Addendum to Arboricultural Report (009978) - Design Review – Brandon Park Shopping Centre

I advise the following in relation to the tree impact assessment undertaken with regard to the proposed Residential and Mixed Use developments in the northeast corner of Brandon Park Shopping Centre, in Wheelers Hill.

Figure 1. Edited extract of DA060 – Demolition ground plan (tree numbers added).

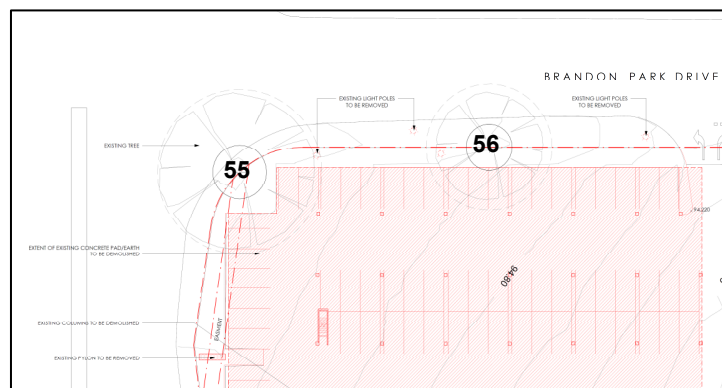
- a. **Demolition:** As shown in Figure 1, demolition includes removal of the existing carpark, including the asphalt road surface and the raised carpark structure. As shown in Images 1-2 and in Figure 1, the carpark kerb and asphalt surface are close to both trees, so there is a moderate possibility that tree roots exist here. It is therefore important that the demolition is undertaken in a root sensitive manner to protect any underlying roots from damage.

Figure 2. Edited extract of DA100A (proposed mezzanine plan). Tree points coloured according to arb rating; Bright green = High, Light green = Mod.A. Light blue circles = TPZs, magenta circles = SRZs.

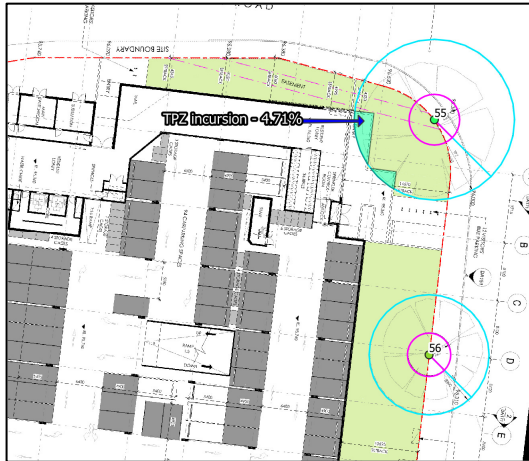
- b. **Ground floor:** As shown in Figure 2, the ground (lowest) floor of the proposed residential building would intercept the TPZ of Tree 55 by ~4.7%. This is considered minor TPZ encroachment under the Australian Standard (AS4970) and this level of incursion is not expected to impact the tree's ongoing viability or condition. It is noted in Figures 5&6, that fill is proposed between the new building and both tree stems. The following is recommended to prevent fill impacts to the tree root zone:
- i. The level of the existing permeable environment should remain unaltered.
 - ii. Fill over the existing asphalt area will likely be tolerated although this should be kept to a depth of <100mm within 5 metres of the trees.
 - iii. If a retaining wall is required to achieve this, the wall should be supported by isolated pegs or similar, i.e. a continuous strip footing should not be used.

Figure 5. Extract of DA183 (street interface section), relative to Tree 55.

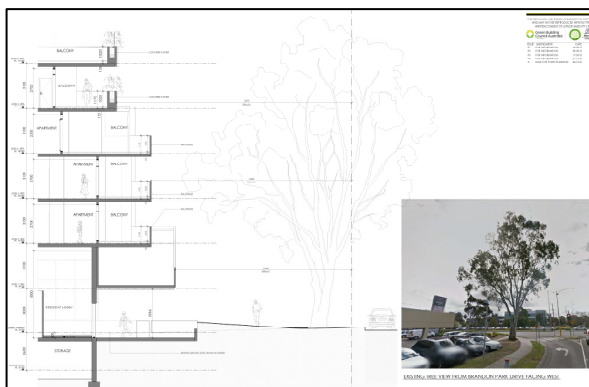
- c. Above ground floors:** Figures 5-9 indicate that there will be no physical conflict between the building and either tree crown although some minor pruning may be required, depending on construction requirements (e.g. scaffolding). The 'architectural canopy' on the corner of the building is the only area that may come into close proximity to the crown of Tree 55 during construction (as seen in Figures 8 & 9). If any pruning were required, it would be removal of one lower branch (<5% total live crown), which the tree would be expected to tolerate. Tree 56 is set back adequately from the proposed building and there would be no anticipated pruning requirements.

Figure 10. Edited extract of DA060 – Demolition ground floor plan (tree numbers added). Tree numbers colour coded according to arb. rating; light green = Mod.A, yellow = Mod.B, orange = Mod.C.

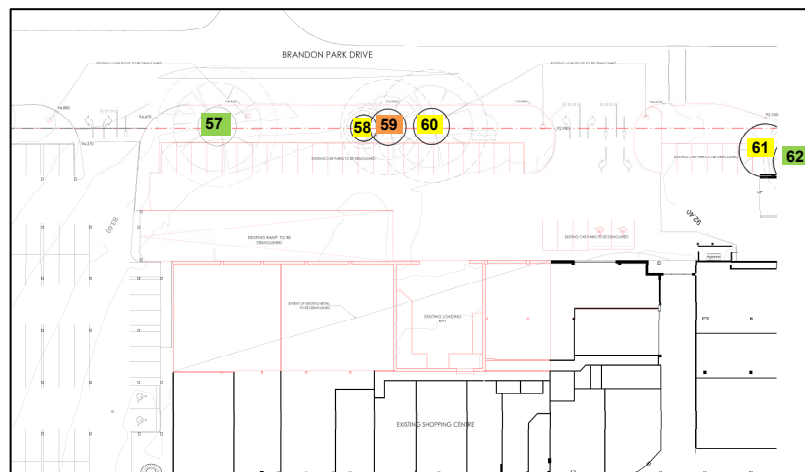
- a. **Demolition:** As shown in Figure 10, demolition includes removal of the existing carpark, including the asphalt road surface and kerbs along with existing ramp, loading bay and part of the retail building. As shown in Images 3-5 and in Figure 10, the carpark kerb and asphalt surface are close to all trees (aside from Tree 62), so there is a moderate possibility that tree roots exist here. It is therefore important that the demolition is undertaken in a root sensitive manner to protect any underlying roots from damage.

Figure 11. Extract of DA100 – proposed ground floor plan

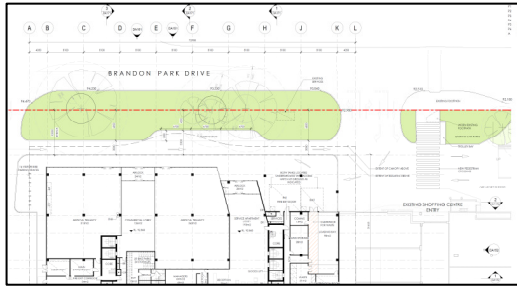
- b. **Ground floor:** As shown in Figures 11 & 12, the proposed ground floor plan will result in no additional TPZ encroachment into any of the five trees and will expand the permeable growing environment of all trees. Nevertheless, construction of the new road and waiting bays will take place within some TPZs so care needs to be taken to ensure any underlying roots are not damaged. It is noted in Figure 14, that fill is proposed between the waiting bays and the trees. The following is recommended to prevent fill impacts to the tree root zone:

- i. The level of the existing permeable environment should remain unaltered.
- ii. Fill over the existing asphalt area will likely be tolerated although this should be kept to a depth of <100mm within 5 metres of the tree.
- iii. If a retaining wall is required to achieve this, the wall should be supported by isolated pegs or similar, i.e. a continuous strip footing should not be used.

Figure 13. Extract of DA101 – Proposed level 1 plan.

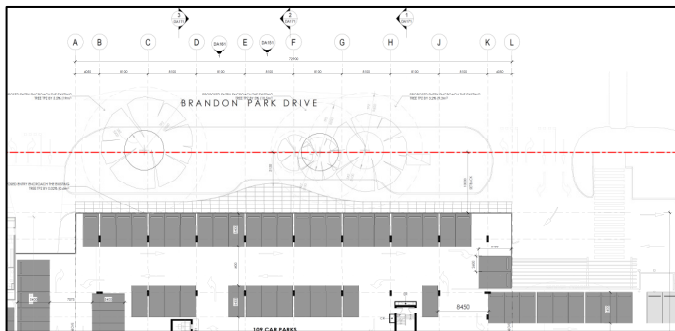
- c. **Above ground floors:** The section diagram at Figure 14 measures the relative setback of the building edge to the site boundary at ~10m. This should be sufficient space for construction activities to take place without requiring any canopy pruning. The only part of the design that comes closer is the architectural canopy extending from the first floor, although as shown in Figure 13, this is positioned outside the canopy of the larger trees so it is also not expected to necessitate any canopy pruning.
